Resource Consent Application LUC-2020-631, 30 Tunnel Beach Road, Green Island

TUNNEL BEACH (LUC-2020-631) - RESPONSE TO MINUTE 1 FROM COMMISSIONER

Response to Commissioner Questions

Figure 1: Indicative assessment areas and site boundary

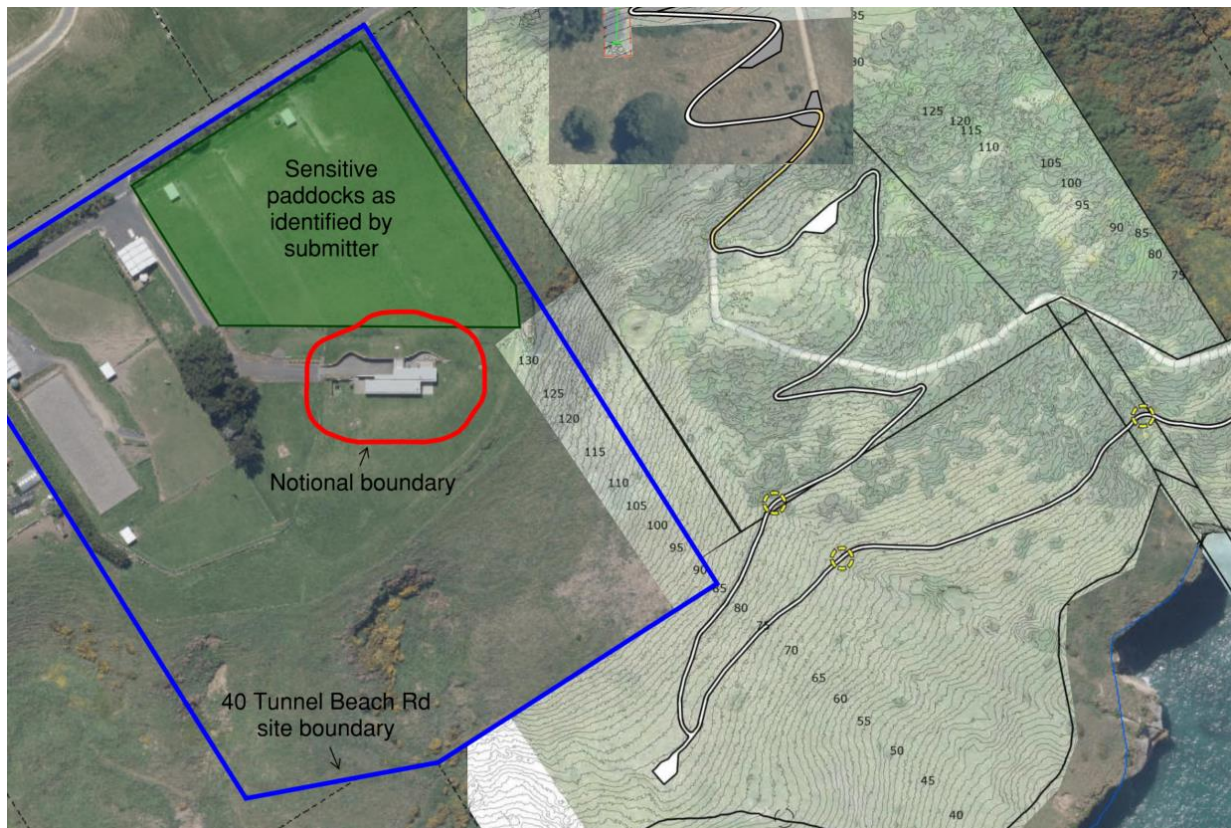
For clarity, Figure 1 shows the site boundary and the sensitive areas used in my assessment. This shows that the track does come closer the site boundary, but not the areas of the site that have been considered sensitive in my assessment.

I predict that noise from people on the track would still be below the daytime noise limit (55 dB L_{Aeq}) at the closest part of the site (approximately 10m from the track). Viewpoint (VP2) is located around 50m from the site boundary. I predict that noise from people at VP2 would be 35-40 dB L_{Aeq} .

Figure 1: General distinction between flat and upper slopes (red) and steep lower slopes (blue).

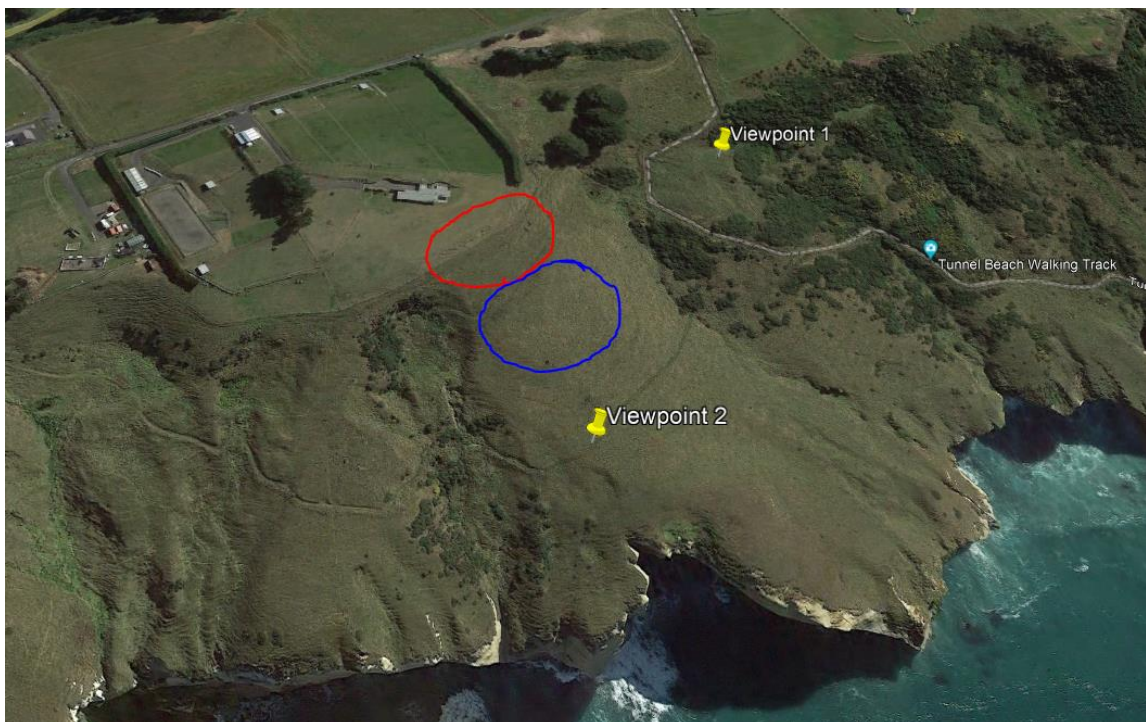
13. In my view the **flat areas to the south of the existing dwelling exhibit a moderate high sensitivity to change**, owing to their proximity to outdoor living areas and use for grazing and working horses. As Ms Durling has indicated in her evidence these areas are regularly used and enjoyed.

14. Conversely **the steep hill faces to the south exhibit a lower level of sensitivity to change** because they aren't accessed, used, and enjoyed in the same manner and frequency as the flatter land to the north. Clearly there is nothing stopping Ms Durling and her partner from accessing this land and potentially standing in relative proximity to the proposed walkway and Viewpoint 2. However, I think the fact that Ms Durling has emphasised (in text and photos) the importance of the flat pasture land to the north and said very little about the potential visual effects on steeper hill faces to the south emphasises the difference in sensitivity to change between these areas.

Figure 2: Additional planting adjacent to Viewpoint 1

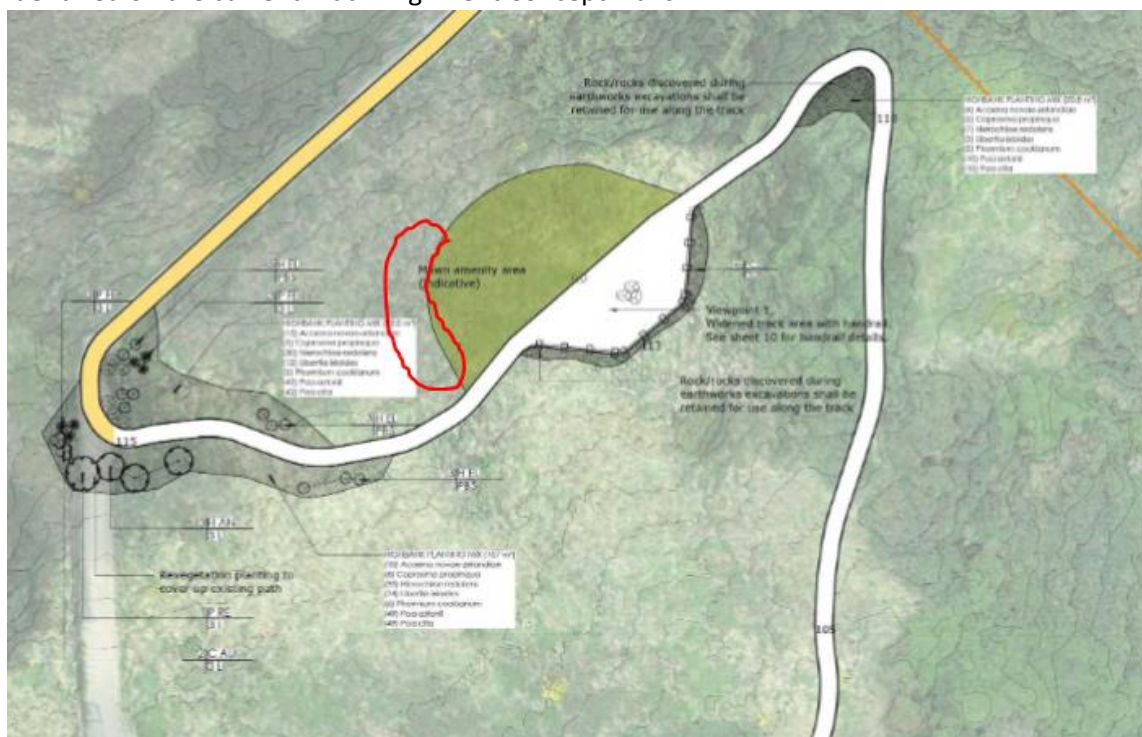
32. Despite a relatively low degree of effect, and certainly less than significant, I do see benefit in additional planting being undertaken in the indicative areas shown in Figures 2 – 4 below and recommend the Crown consider this assessment in their development plans. The purpose of this planting is not necessary to achieve the 'less than significant' test in s4(3), rather it is to respond to the perceived impacts of the proposal on Ms Durling and her property and to provide screening of the proposed works.

33. In my opinion 'block planting' of predominantly ngaio (*Myoporum laetum*) would be the most effective approach to achieving a visual screen in these locations. It is widespread on the coastal hill faces and grows to a favourable height and density. There is also potential to supplement with other lower growing species so these areas are consistent with the 'Highbank Planting Mix' identified on the current Track Alignment Concept Plans.
